RE: DRAFT ENVIRONMENTAL ASSESSMENT FOR THE RENEWAL OF U.S. NUCLEAR REGULATORY COMMISSION LICENSE NO. SNM-124 FOR NUCLEAR FUEL SERVICES, INC., DOCKET NO. 70-143

RE: DOCKET ID NRC-2009-0435; COMMENTS ON DRAFT ENVIRONMENTAL ASSESSMENT FOR THE RENEWAL OF U.S. NUCLEAR REGULATORY COMMISSION LICENSE NO. SNM-124 FOR NUCLEAR FUEL SERVICES, INC., DOCKET NO. 70-143, OCTOBER 2010

ENCLOSURE: Public Comments on Draft Environmental Assessment (Draft EA) for Proposed Renewal of Nuclear Fuel Services' (NFS) Special Nuclear Materials (SNM) License for 40 Years

Age-Adjusted Non-Hodgkin's Lymphoma Cancer Death Rates per 100,000, All Races, All Ages, Both Sexes Unicoi Co, Northeast, and TN 1990-2006

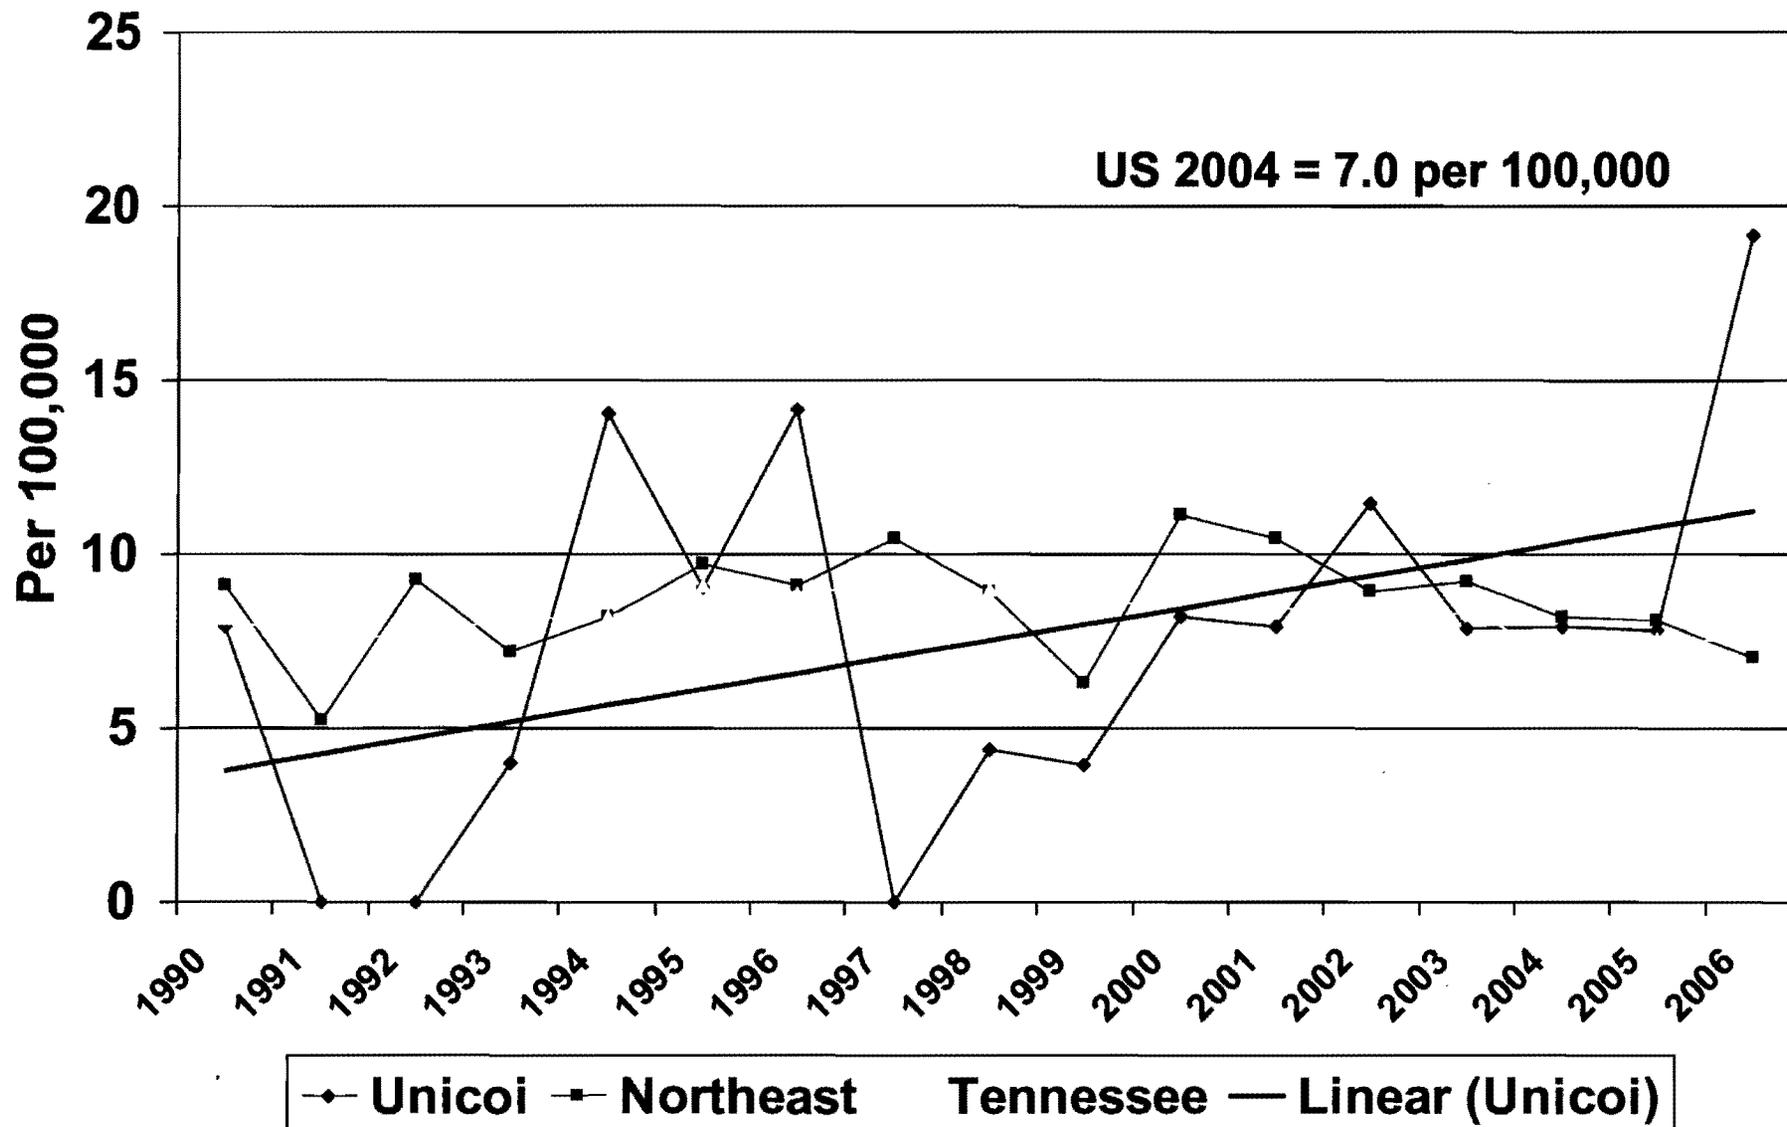
operations are not cumulatively significant, why did Non-Hodgkin's Lymphoma Cancer death rates almost triple from 1990 to 2006? (Attachment) And, with it already taking 1-3 months for the NRC to answer basic questions about NFS's license, how can the public have any confidence whatsoever that the NRC will be able to keep track of the provisions of a license with 360 (or more) amendments? Finally, given the fact that independent safety experts found, in back-to-back scathing reports, that NFS lacks a credible Safety Culture, and given the fact that NFS is perennially before AARM proceedings & under Escalated Enforcement -- including several recent Confirmatory Orders involving fitness-for-duty issues and falsification of fire-safety documents -- and because of serious Environmental Justice concerns, even a 2-year renewal of NFS's license doesn't seem warranted without an EIS.
